Lightning Protection Systems

ATLAS Enquiry Cases

The following enquiry cases have been received by the ATLAS Lightning Protection Committee regarding the interpretation of BS EN 62305, the recognised British Standard for the design, installation and testing of lightning protection systems.

Ref. 06: Ridge Conductor (4 December 2009)

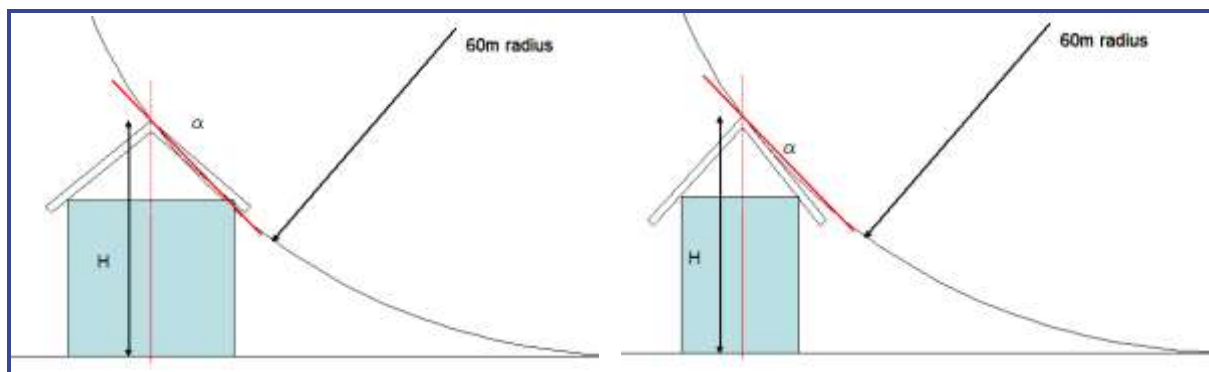
Will a ridge conductor offer protection over the eaves of a pitched roof?

There are three methods of providing protection: the mesh method, the protective angle method and the rolling sphere method. One or a combination of these can be applied to the design process. In this case, the protective angle method would be applied on its own. The designer would need to look at the reference plane on relation to the ridge conductor and carry out the assessment as per Part 3 Table 2.

E.14, 15 and 16 show various scenarios using the protective angle method on pitched roofs but does not appear to offer an example using just a ridge conductor. However ignoring the fact we have an eave at all, the angle of protection will apply in all cases (see below).

The area under the zone of protection is the same with or without the eave, with respect to the rolling sphere we can see in the above example how it may also offer protection to the eaves. The above example also shows a shallower pitch where eaves protection would be needed.

Ref. 16: Equipotential Bond to Lifts and Services (5 May 2010)

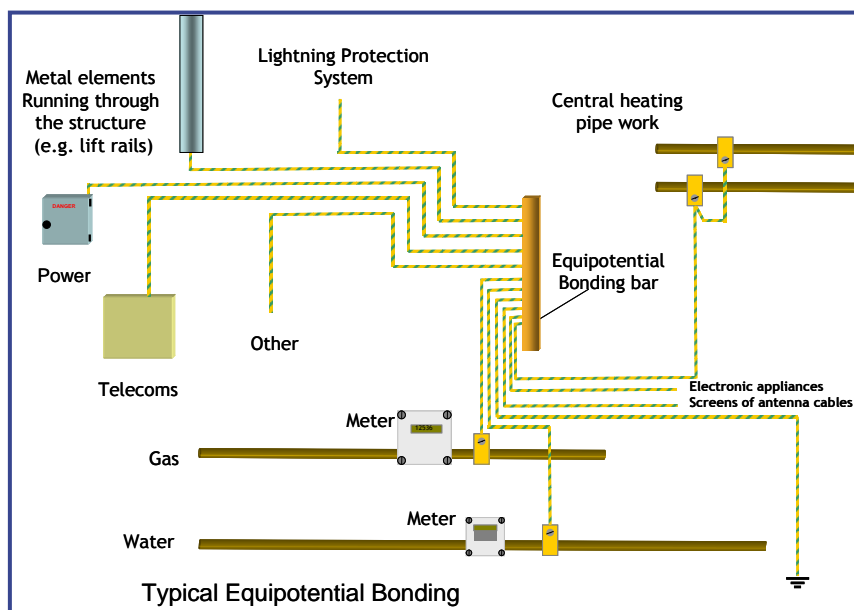
Should the LPS Specialist Contractor allow for the equipotential bonding of the lift guide rails etc. at low level?

Under BS EN 62305-3 E.6.2.2 bonding of metal installations running through a structure should be carried out. This requirement covers water, gas etc. and any lift shaft metal work. The work at ground level would fall under the normal scope of work of the electrical installation or lift engineering company under their requirement for fault protection. It may be prudent to ensure that your client is reminded of this fact and that as a LPS Specialist Contractor you would expect this work to have been covered by the appropriate trade.

Ref. 22: Use of Re-bars in Structural Reinforcing as the Down Conductor (29 August 2013)

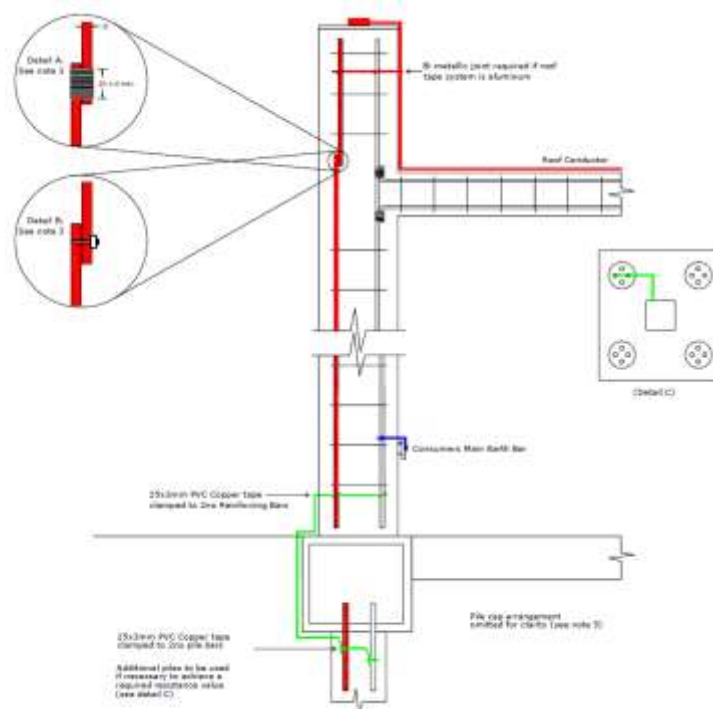
When utilising the cast in-situ structural reinforcing as the down conductor, please clarify the method, type and quantity of the connections to, and between, the re-bars.

BS EN 62305-3:2011 E.4.3.3 defines the method, dimensions and quantity of connection methods.

For the purpose of carrying lightning current, the available options to provide electrical continuity in a re-bar are illustrated in BS EN 62305-3:2011 Figure E.5 and are defined as;

1. Welded connections (with a minimum weld length of 50 mm)
2. Clamped connections (with components conforming to IEC/BS EN 65265-1)
3. Bound joints (overlapped 20 times the rebar diameter and fully bound along this length)

Lashed joints (simple twisted wire ties) are only considered suitable for EMC purposes i.e. not for carrying lightning current.

For connections to and from the re-bar at, say, roof and ground level there shall be two conductors connecting to different re-bars or one conductor extended to connect to two different re-bars.
